ADDENDUM 3  
REPORT ON CONTAINMENT BUILDING RING GIRDER  
CONSTRUCTION AND REPAIR

THREE MILE ISLAND NUCLEAR STATION  
UNIT NO. 1

METROPOLITAN EDISON COMPANY

Request for Additional Information

FIGURE 1  
TYPICAL EXTENT OF REPAIRS

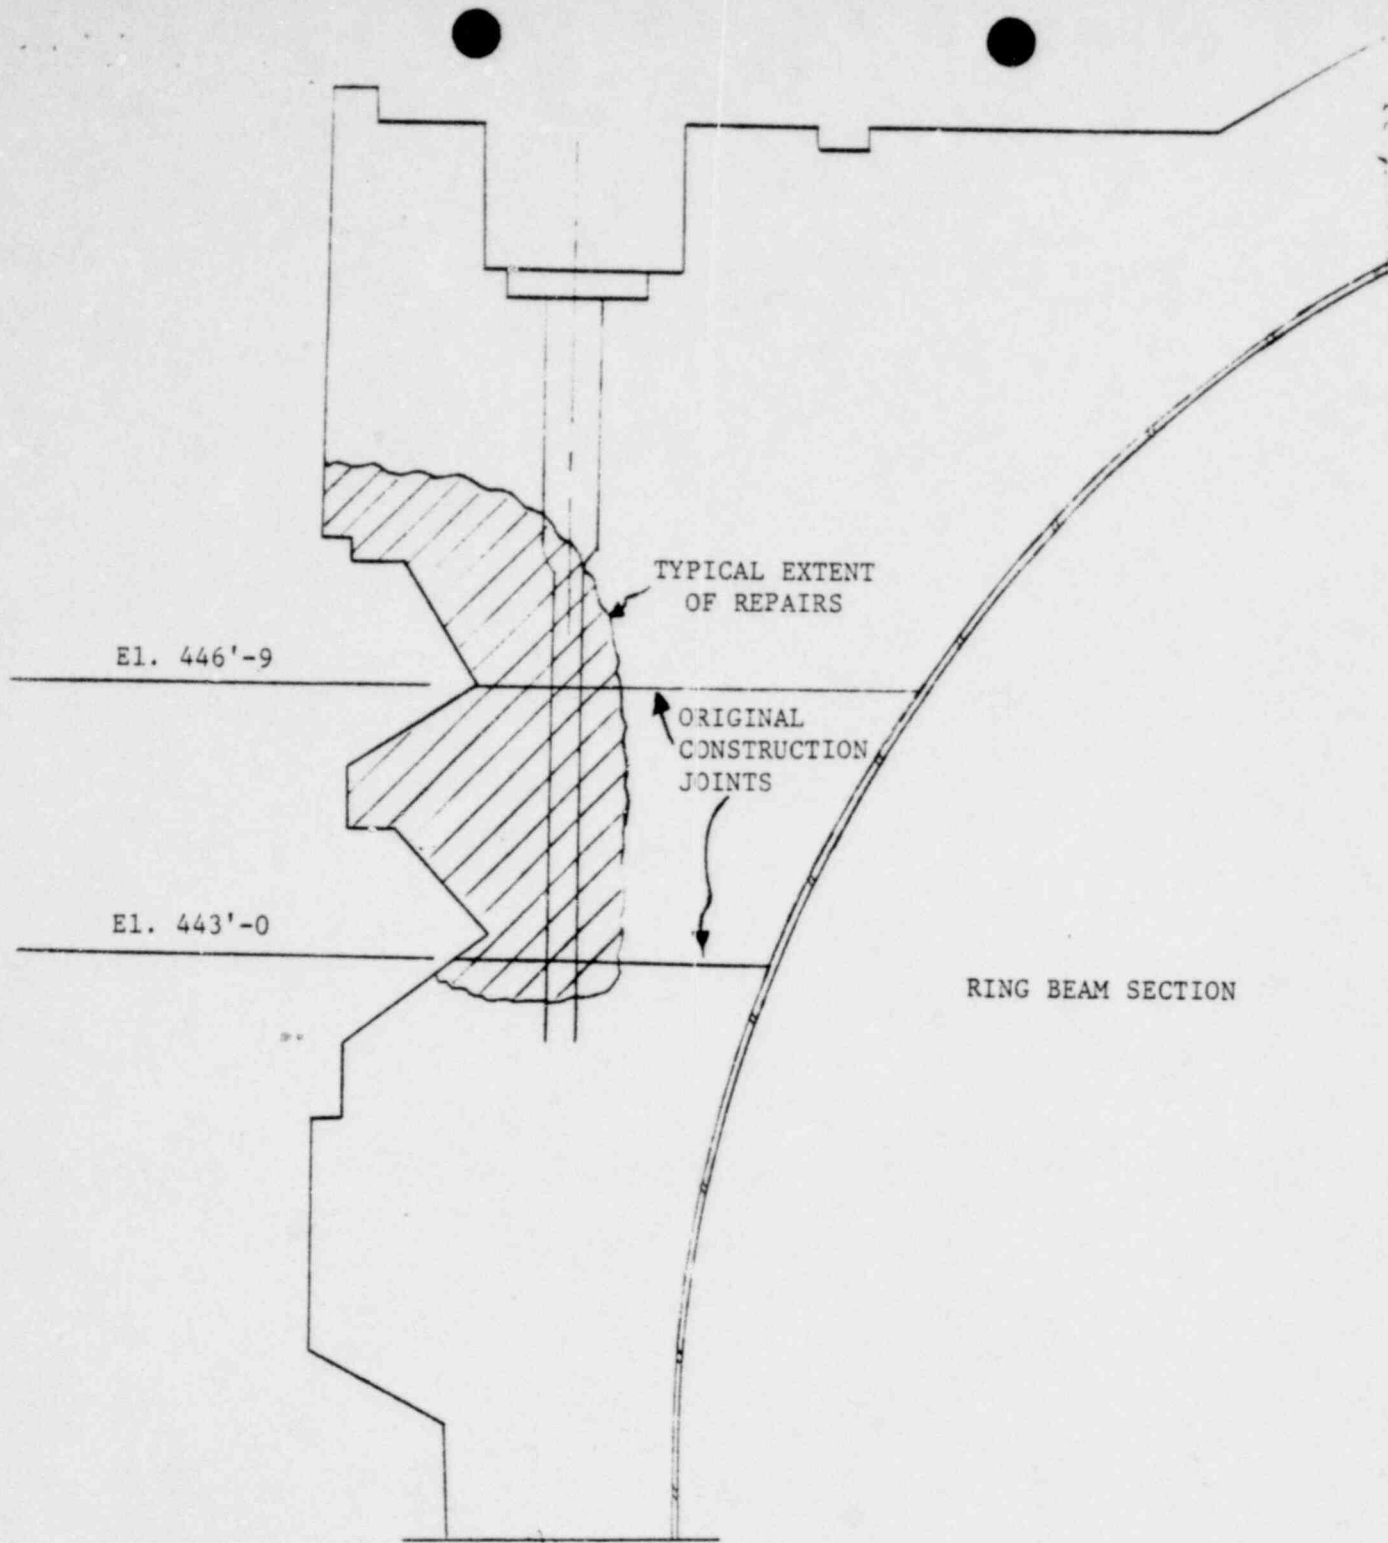
- 5.25 The Addendum #2 should present, in addition to the four loading cases listed (normal operation, test condition, accident condition, initial prestress), the load combinations which include the OBE, DBE, airplane impact and tornado loads. A listing of minimum safety factors in the repaired girder joints should be included. Where the shear bars are used to carry also the bursting forces due to prestresses and the tensile stress concentrations due to tendon curvature and the "hole" effect of flexible sheathing, the corresponding loads should be included in the analysis. The effects of shrinkage, creep of concrete, and relaxation of prestressing should be considered in all cases where they may modify the normal forces acting on the horizontal joints and therefore change the friction resistance of the joint.

The horizontal ring girder construction joint condition at elevations 443 ft-0 in. and 446 ft-9 in. has changed substantially from that investigated in Addendum 2 to the Ring Girder Report. Concrete excavation into the ring girder has extended up to and behind the vertical tendon conduits for more than fifty percent of the South 180°. Figure 1 indicates the extent of concrete removal for the South 180°. Construction joints for the replacement concrete will be located at different elevations than the original joints. In addition all joints will be carefully prepared ensuring complete aggregate interlock at the joints. The shear study on the construction joints presented in Addendum 2 was based on assumptions that are no longer valid; namely, the construction joints at elevation 443 ft-0 in. and 446 ft-9 in., extending horizontally across the full thickness of the ring girder, utilize only friction for transferring shear. The repair will provide complete aggregate interlock at the new construction joints, located at different elevations than the original construction joints.

Shear resistance across the thickness of the ring girder at elevations 443 ft-0 in. and 446 ft-9 in. should be as good as that intended by the original design following the repair. The original design was not based on a factor of safety analysis; however, a reasonable estimate of the minimum factor of safety at these two elevations against shear loading on the repaired ring girder would be two.

Shear bars are not used to carry bursting forces due to prestress. There are no tensile stress concentrations due to tendon curvature in the ring girder because all tendon trajectories are straight within the ring girder. The "hole" effect of the flexible sheathing will result in a small increase in stress around the hole. However, since the concrete stress in the area around the tendon sheathings is low, the net result of the redistribution of stresses into the concrete around the holes is still within the allowable concrete stresses.
